SUBDIVISION REVIEW SHEET

CASE NO.: C8-2020-0141

SUBDIVISION NAME: Velocity Preliminary Plan

CITY OF AUSTIN –DEVELOPMENT SERVICES DEPARTMENT SUBDIVISION APPLICATION – MASTER COMMENT REPORT

PRELIMINARY SUBDIVISION APPROVAL SHEET 1 OF 26

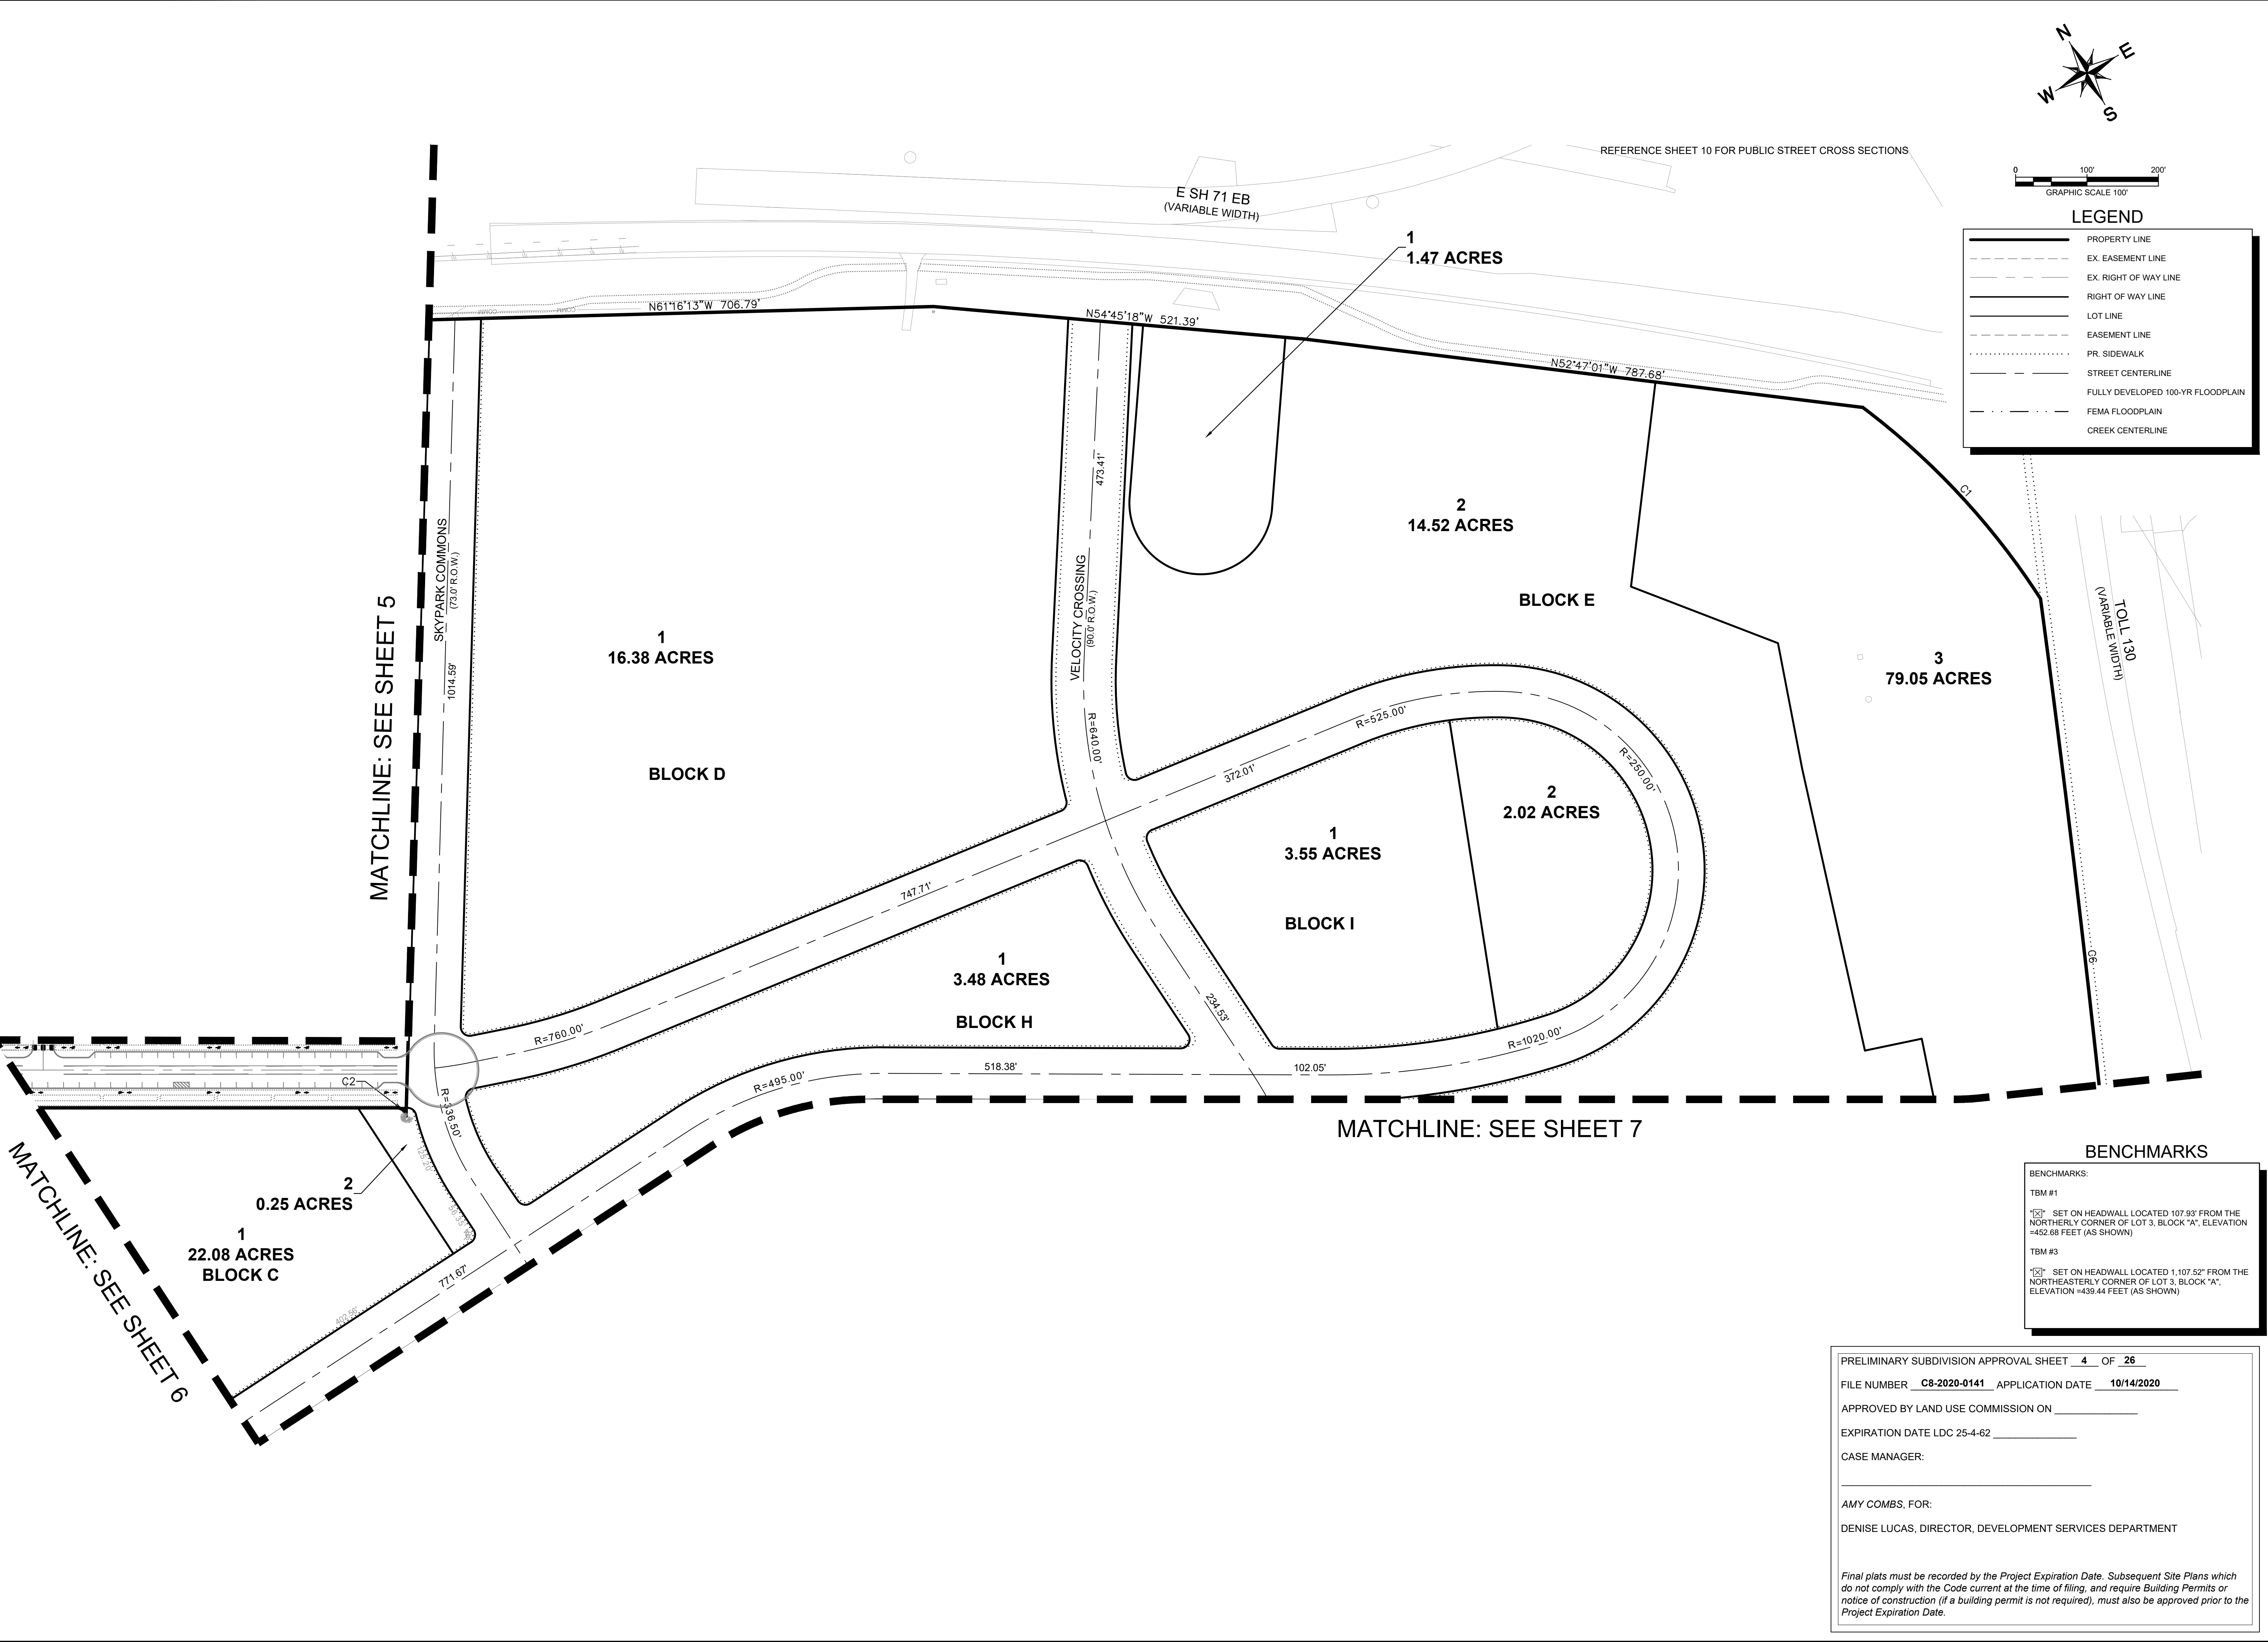
SR13. Please update note 12 B. on sheet 2 to reflect the following- updating Skypark Commons to a revised street name:

B. Environmental and safety controls, and other related items (e.g., erosion and sedimentation controls, restoration, channel work, pipe in easements, detention, water quality ponds, etc.) as determined prior to final plat approval. The restoration cost estimate will be based on disturbed areas including the following streets: Velocity Crossing, Skypark Commons, World Drive, and Spirit Drive"

STREET
CROSS-SECTIONS

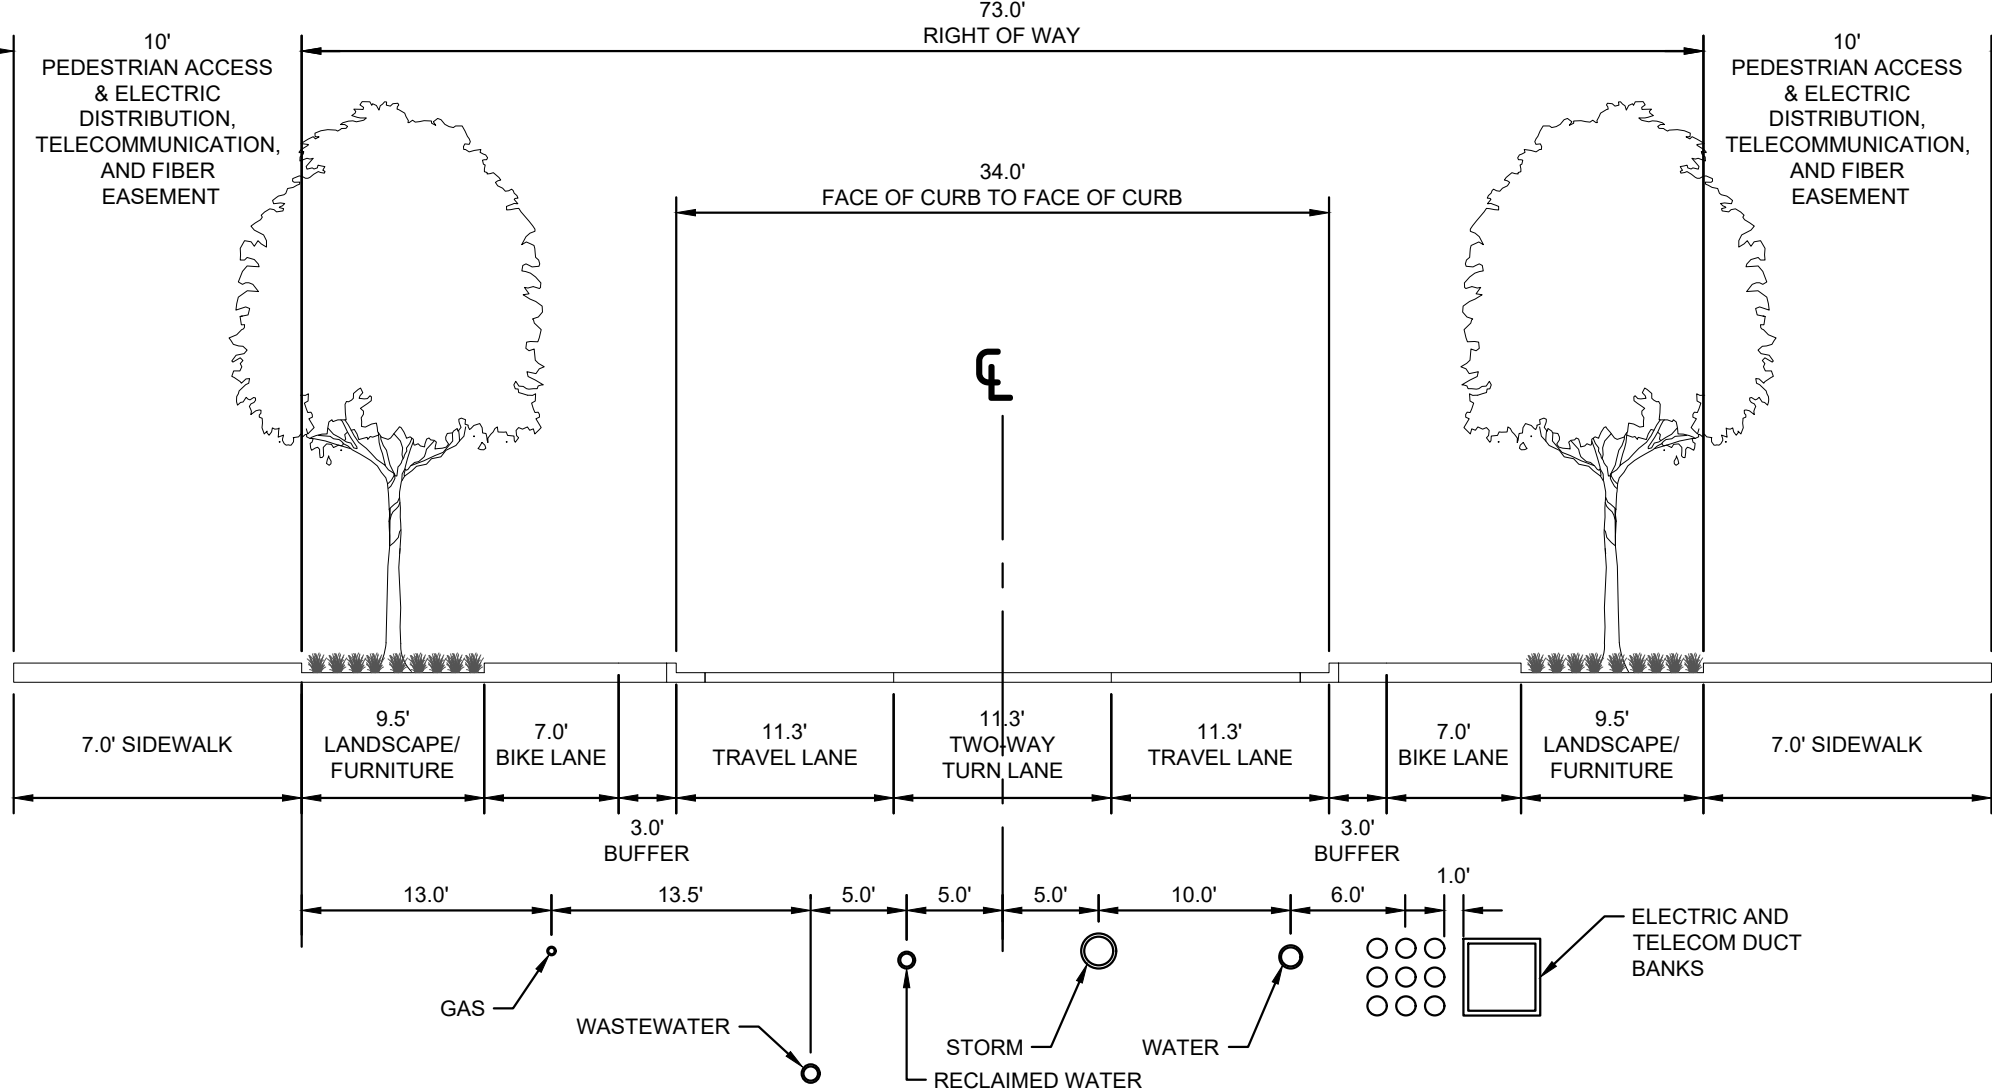
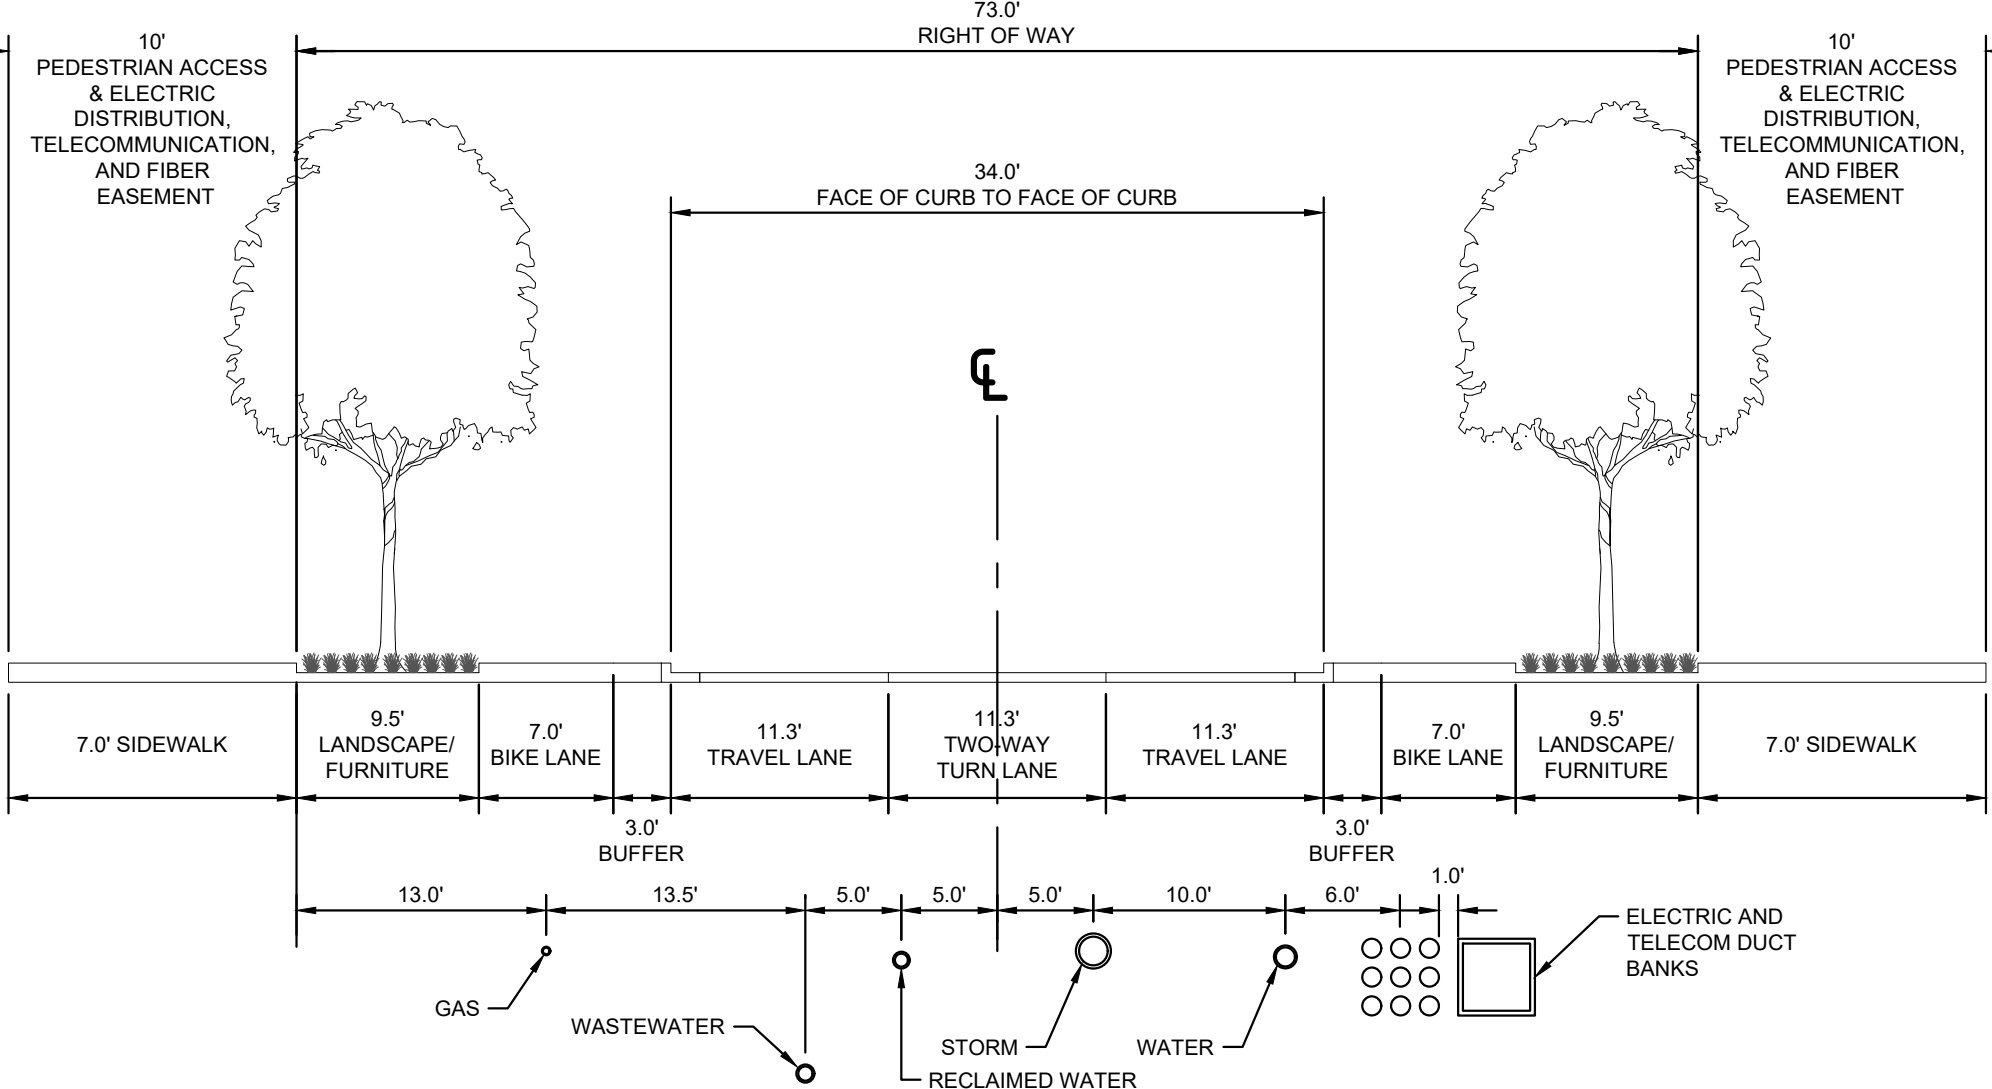
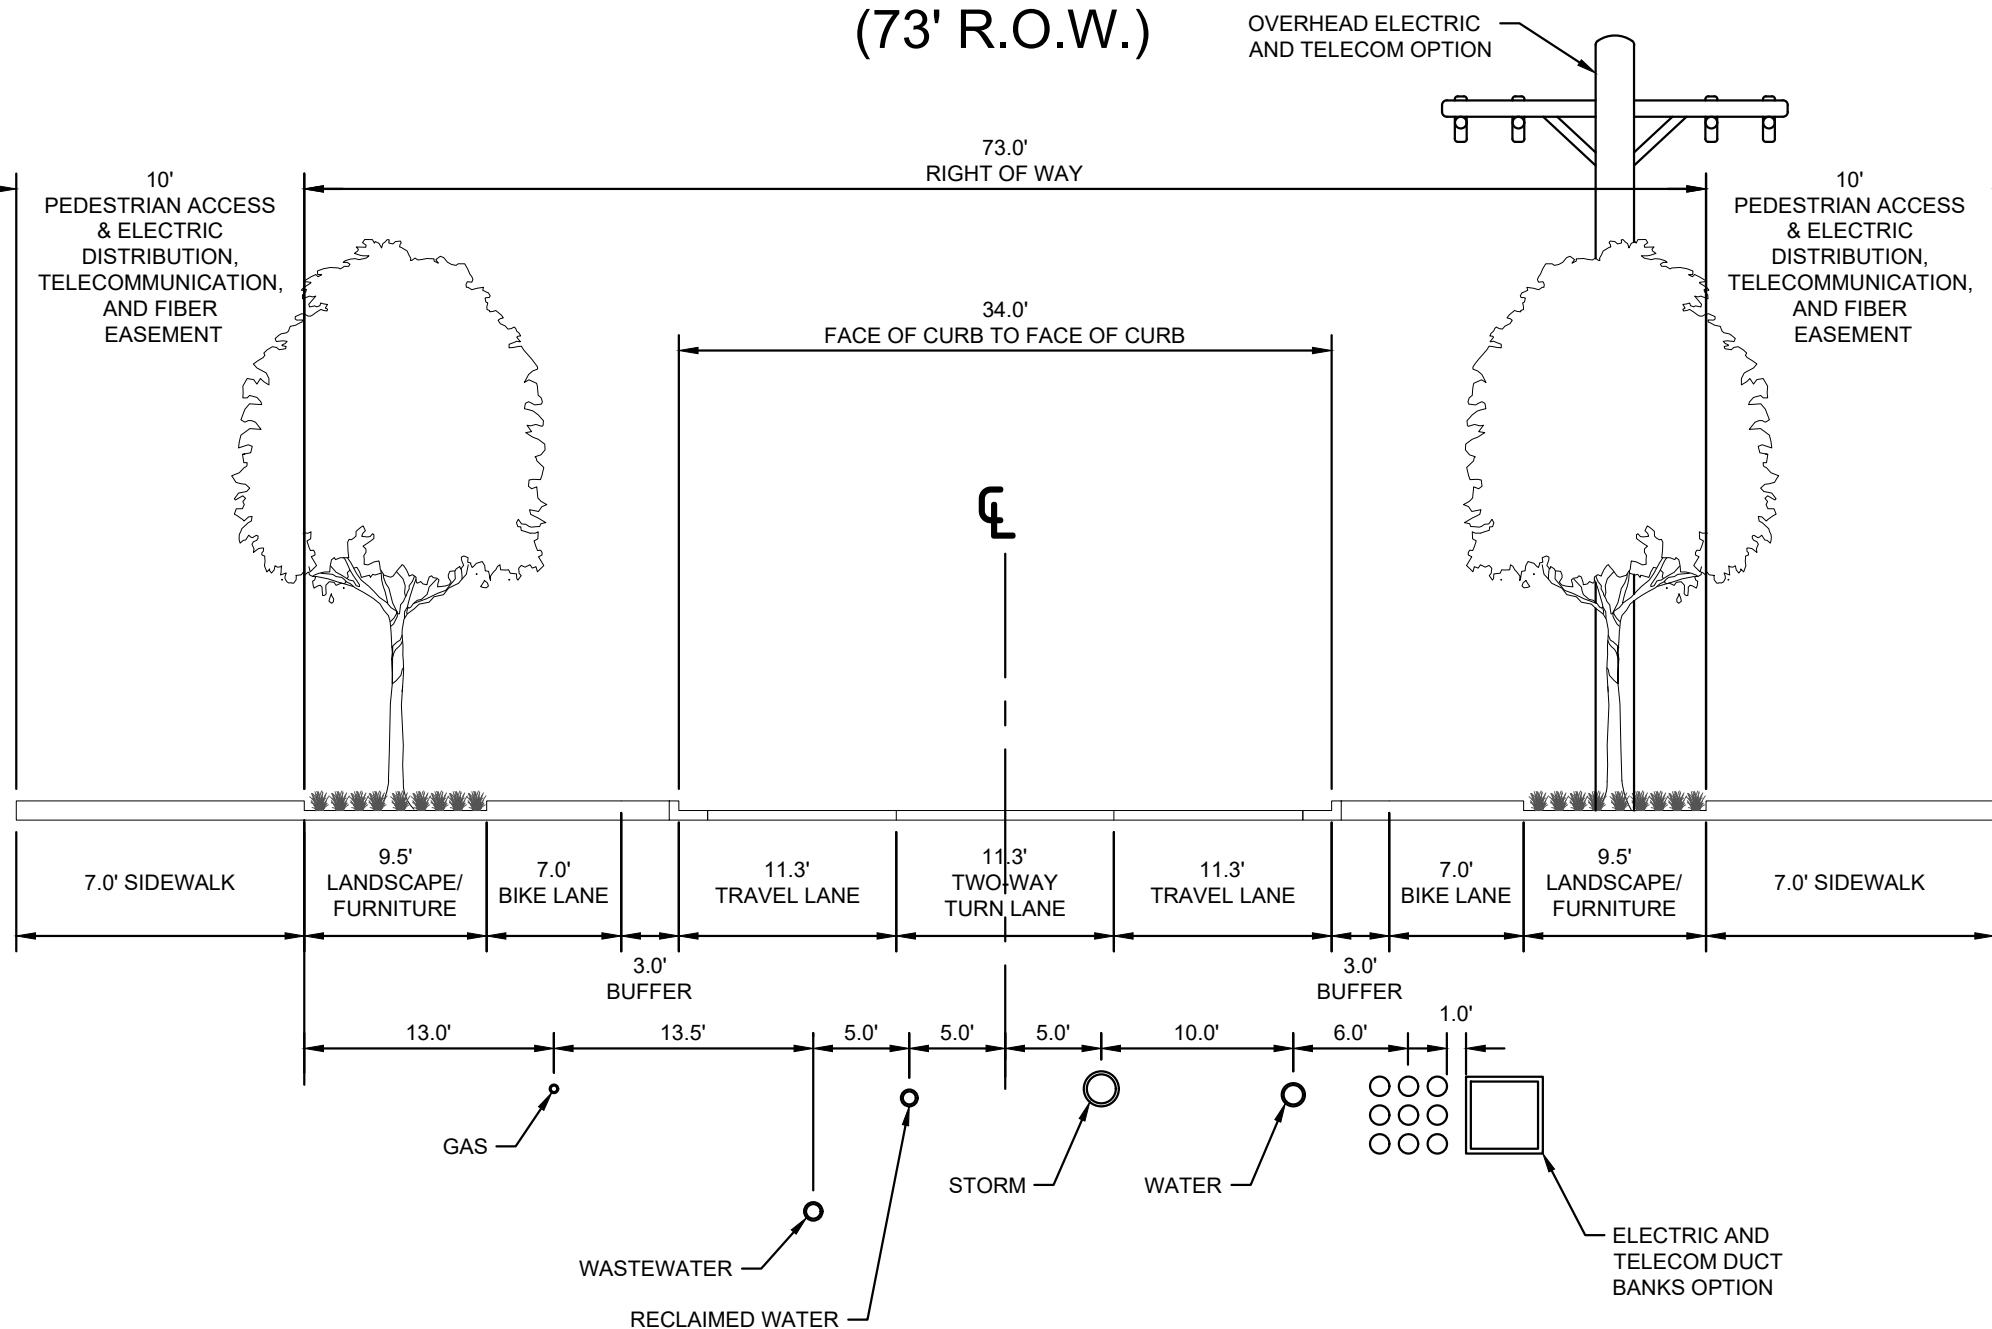
AD1. Not Cleared. SKY PARK COMMONS – Park is on the do not use list NOTE1: Use of the COMMONS street type should be utilized in a high-density area surrounded by grassy knolls or grassy areas as stated in street name reservation standards §25-4-155
